REQUEST FOR ARCHITECTURAL REVIEW BOARD CONSIDERATION

ITEM DESCRIPTION: Review and consideration of architectural plans for Suscha's Bar exterior remodel project at 1054 Pennsylvania Avenue.

REQUEST FOR ARCHITECTURAL REVIEW BOARD CONSIDERATION

ITEM DESCRIPTION: Review and consideration of architectural plans for Suscha’s Bar exterior remodel project at 1054 Pennsylvania Avenue.

Existing

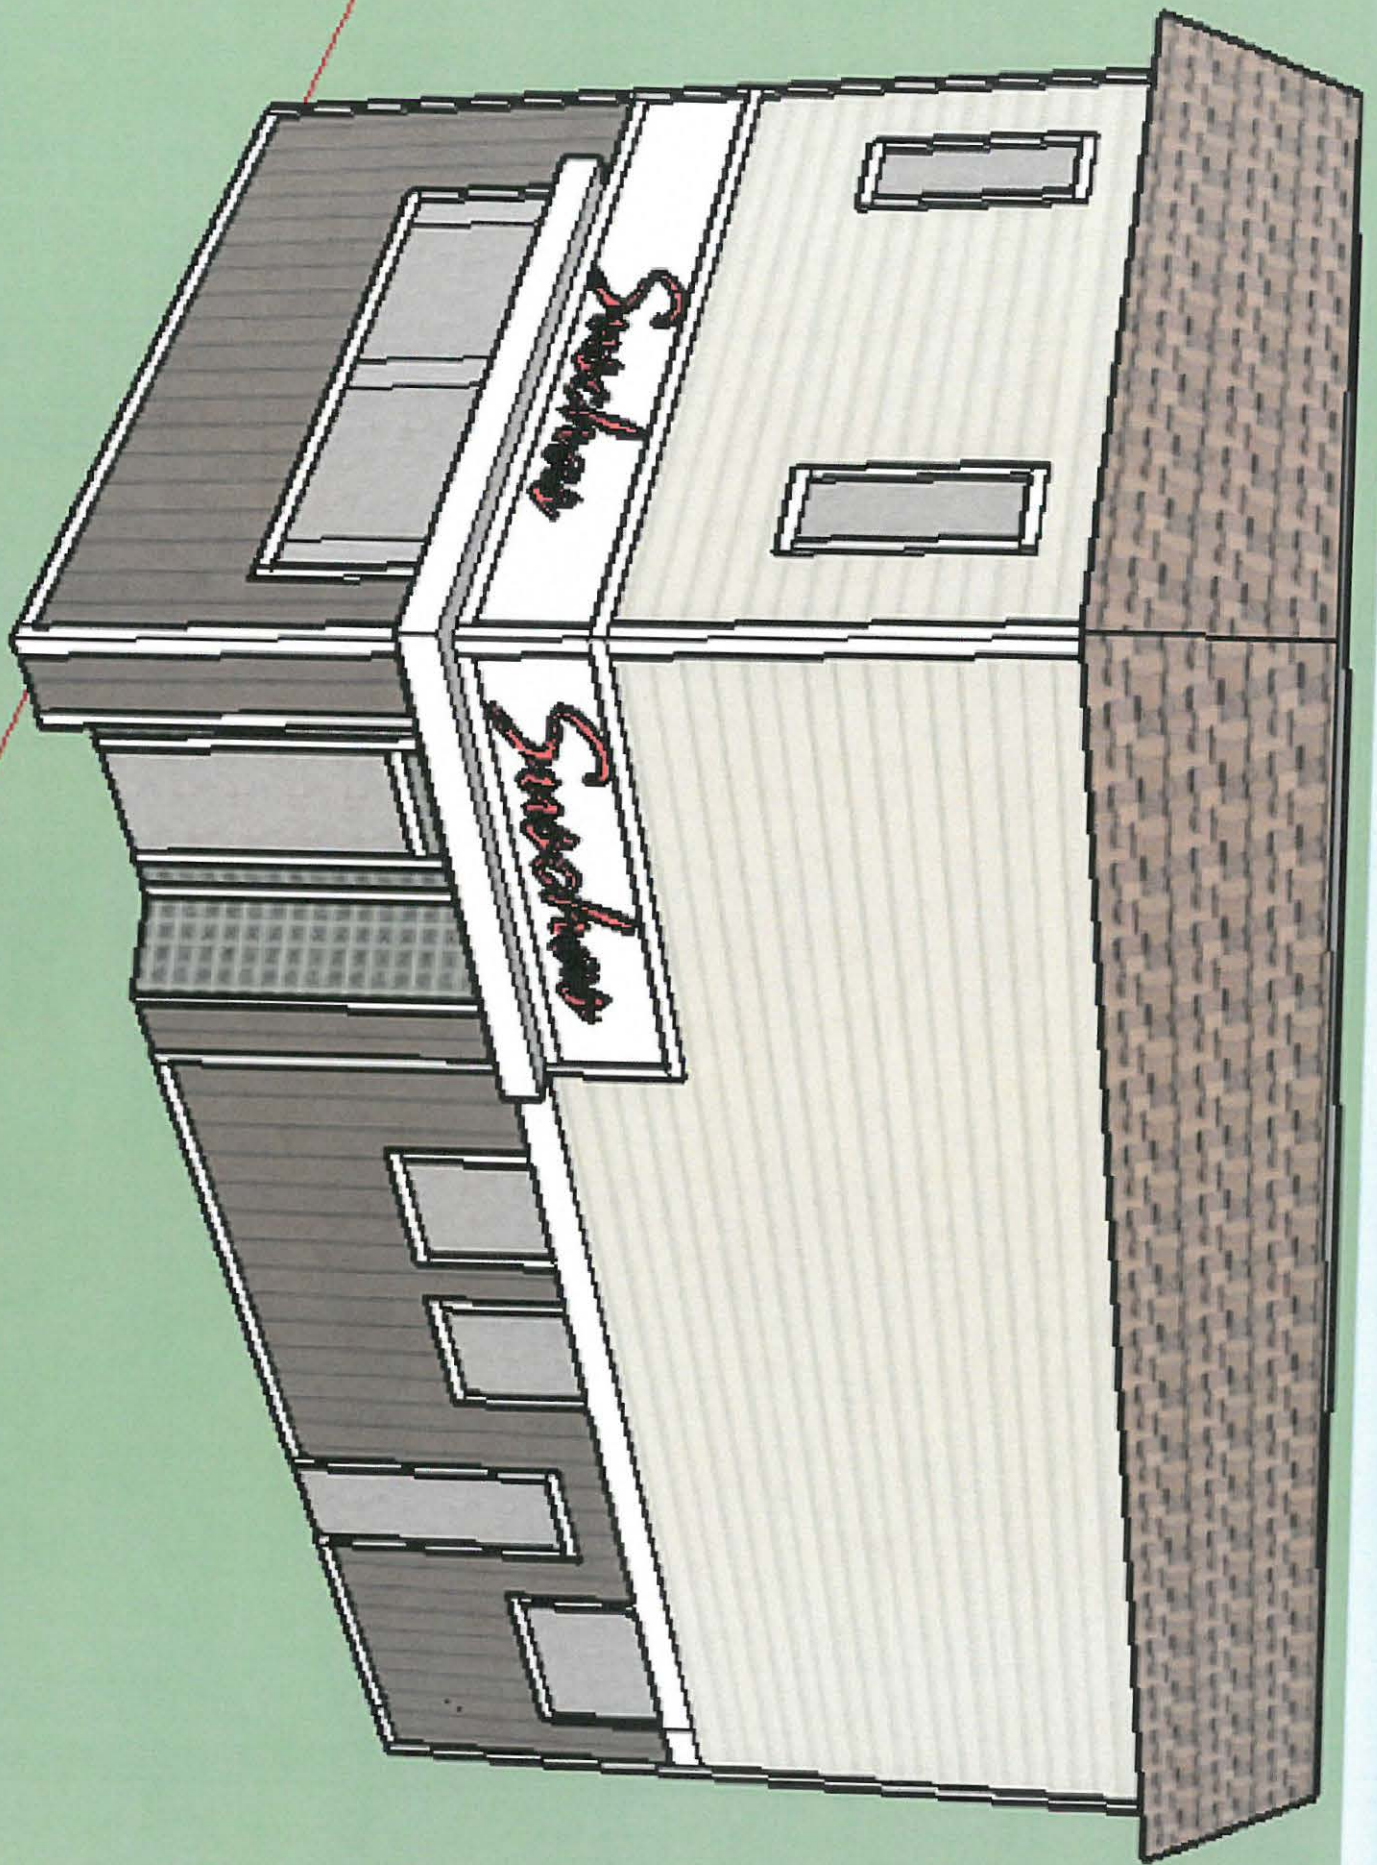
- Replace existing tile on the west and south corner of the building which is failing and falling off the building.
- Replace existing aluminum horizontal siding on lower half of the west and south sides of the building.
- Applicant is proposing to replace the siding and tile with new vertical LP siding in a darker color than the previous tan.

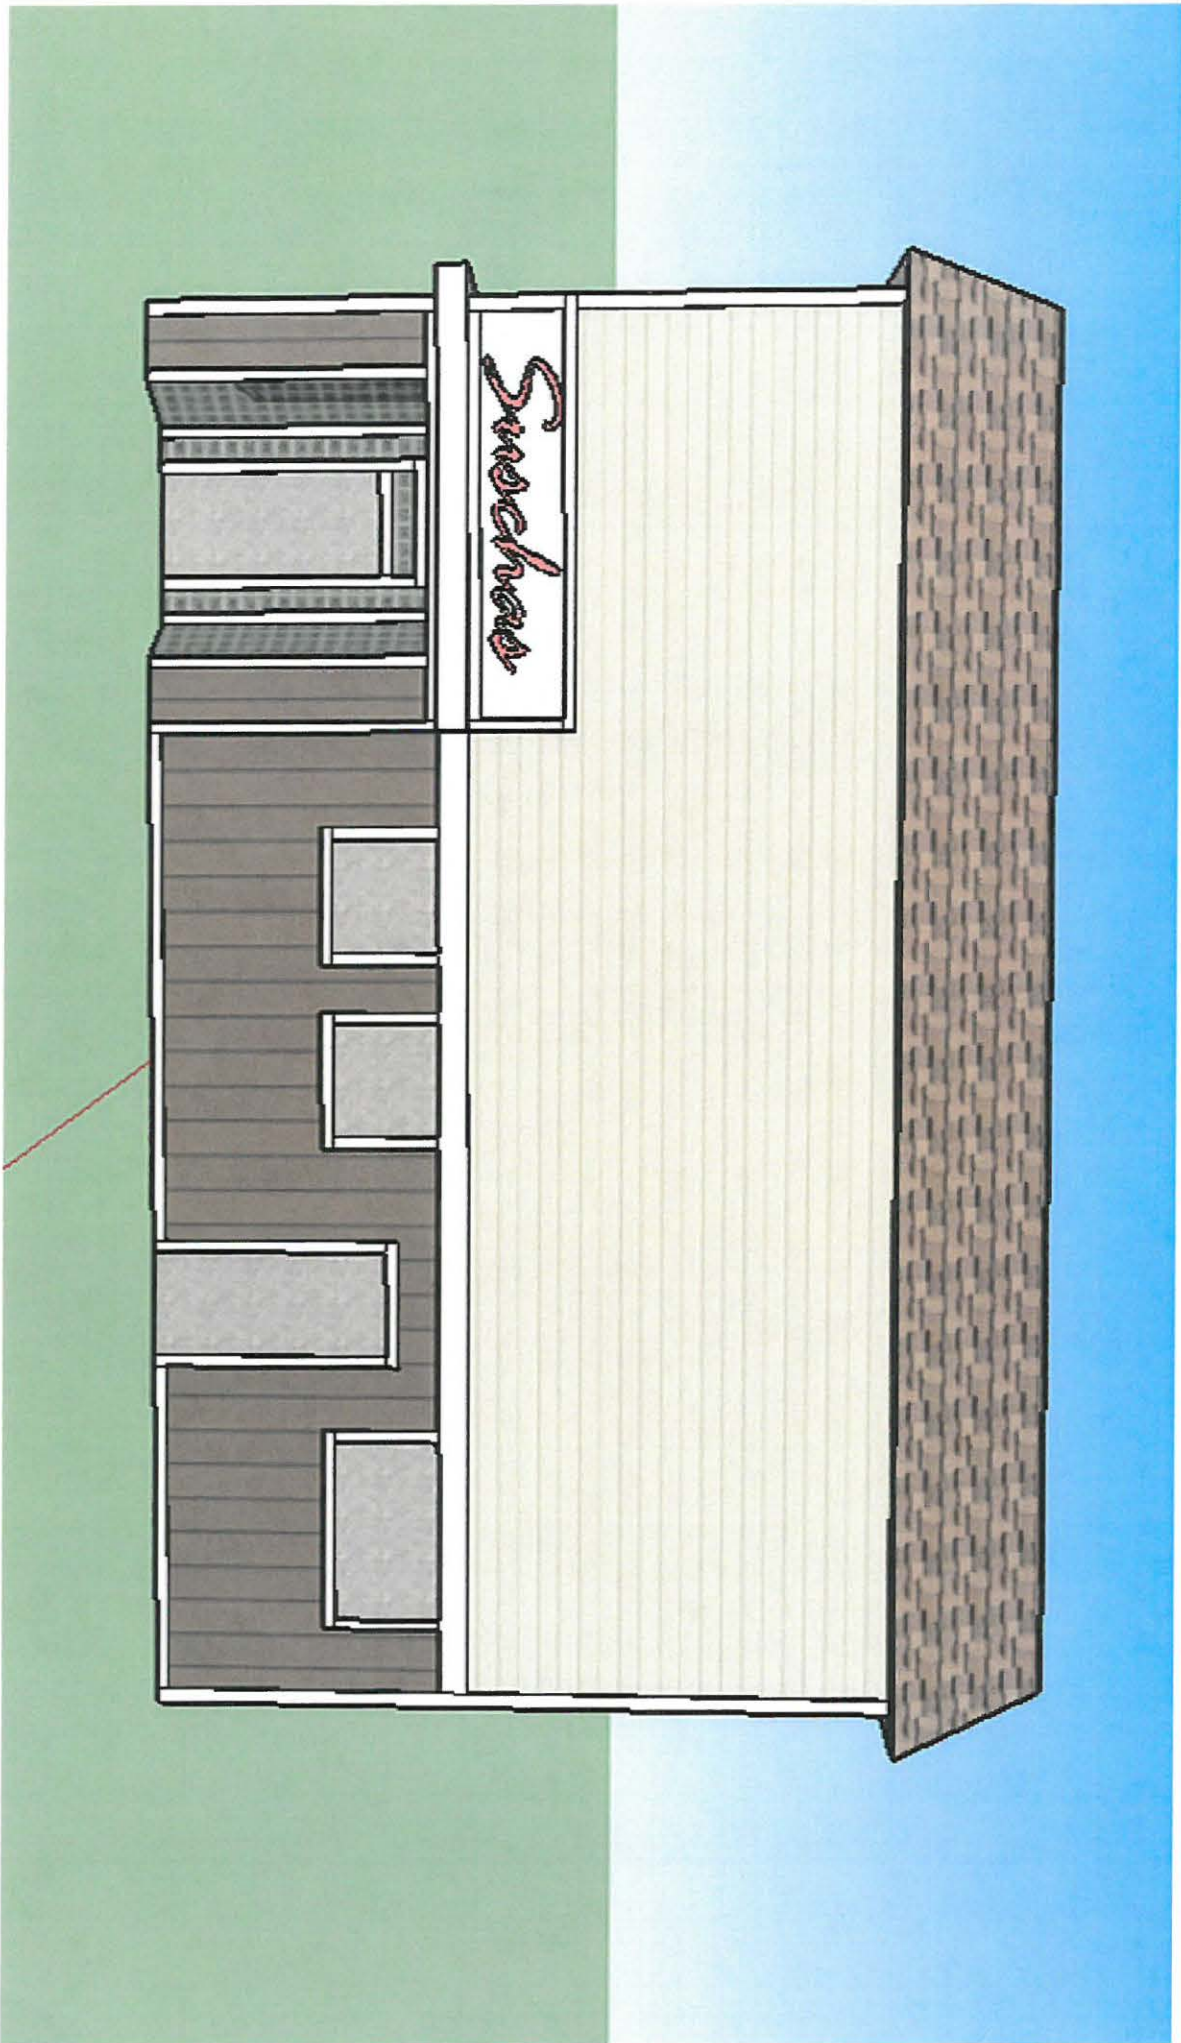
- The horizontal siding on the lower portion completely changes the “separate identity” of the lower portion, and now it’s just a different colored band and has become more integrated with the upper portion of the building.

- The corner-boards and trim band had also been shown as a much more pronounced contrast (and was supposed to relate to the color of the remaining/projecting element that wraps the corner). The current color for those accents leaves the element wrapping the corner as completely foreign.

- The windows on the short-façade had also been shown grouped within a single trim-surround that fell below the sign on that façade, and provided a strong-enough focus to detract from the windows above. The proposed layout with a logo just at the corner, and the two windows trimmed-out separately just makes that façade composition more unbalanced rather than improving anything.

- As far as siding-over the areas that had previously been sign-boards, and just putting new signage over new siding does not appear to be a good approach from a design perspective.

- The sign-boards were one of the items that brought architectural interest to the building. They provide a visually-significant horizontal separation between the new lower portion of the building that was needed in order for the Board to make demands that the upper portion of the building be integrated into their updates.

Motion to approve original drawings with possible amendments as determined by the Board.
